Groundwater Application Review Summary Form

Application # G- 18824

To: Kristopher Byrd, Well Construction and Compliance Section Manager
From: Joel Jeffery, Well Construction Program Coordinator
Subject: Review of Water Right Application G-18824
Date: August 27, 2019

PUBLIC INTEREST REVIEW FOR GROUNDWATER APPLICATIONS

Water-Level Trends in Nearby Wells

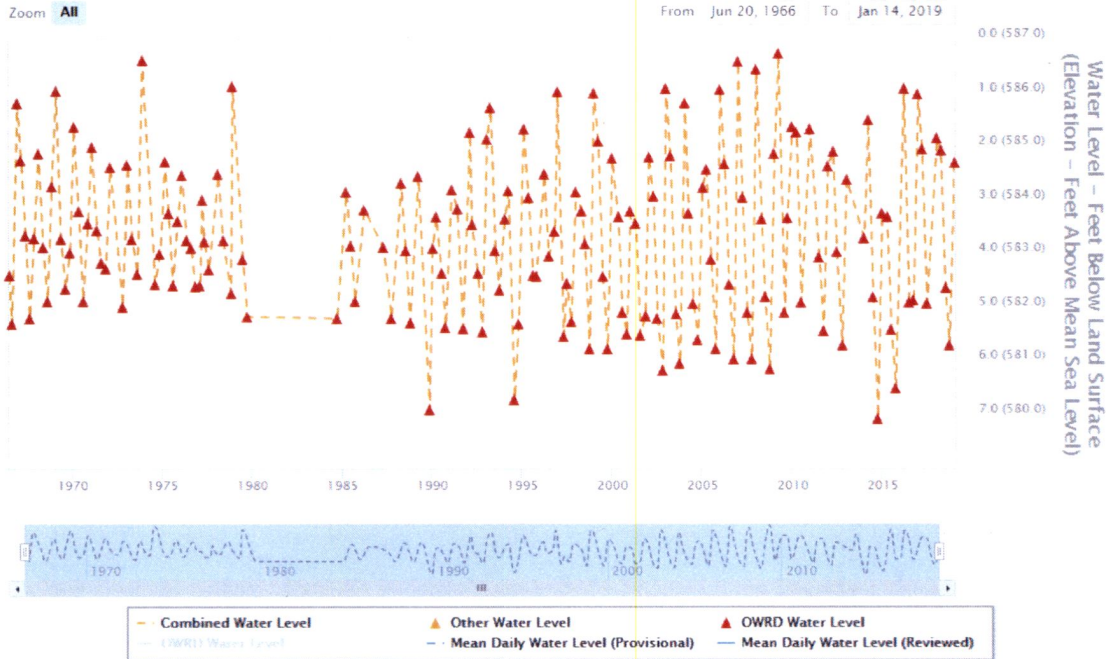
B3. **Groundwater availability remarks:** There are limited water level data in the aquifer and vicinity of the applicant’s proposed POA so Over-Appropriation and Capacity of the Resource cannot be determined and water-level reporting conditions in B1(d) are recommended. There are two permitted groundwater right within 1 mile of the applicant’s proposed POA and it is unlikely that the applicant’s use would result in injury to these permitted water rights given the low rate of appropriation and generally high transmissivity and storativity of the aquifer in the area. However, standard interference conditions should be applied

Stream-Depletion Model Results

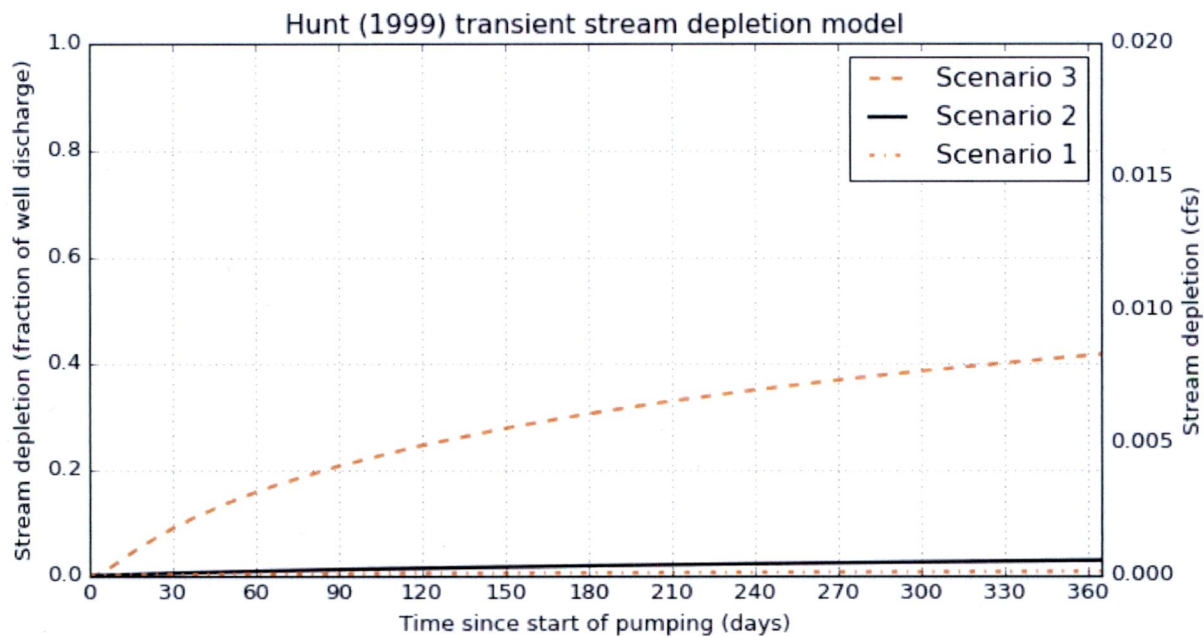
Comments: stream-depletion at 30 d was estimated using the Hunt-1999 stream-depletion model with parameter values representative of alluvial aquifer material.

C6. **SW / GW Remarks and Conditions:** The applicant's proposed POA would be producing from an aquifer that has been found to be hydraulically connected to surface water – specifically the Coast Fk Willamette River – at a distance of less than 1 mile. The proposed maximum rate of appropriation is less than 1% of the pertinent adopted perennial streamflow and also less than 1% of the adopted instream water rights for the surface water source and the estimated stream-depletion is less than 25% after 30 days. Per OAR 690-009-0040(4) the POAs are assumed to **not** have the Potential for Substantial Interference
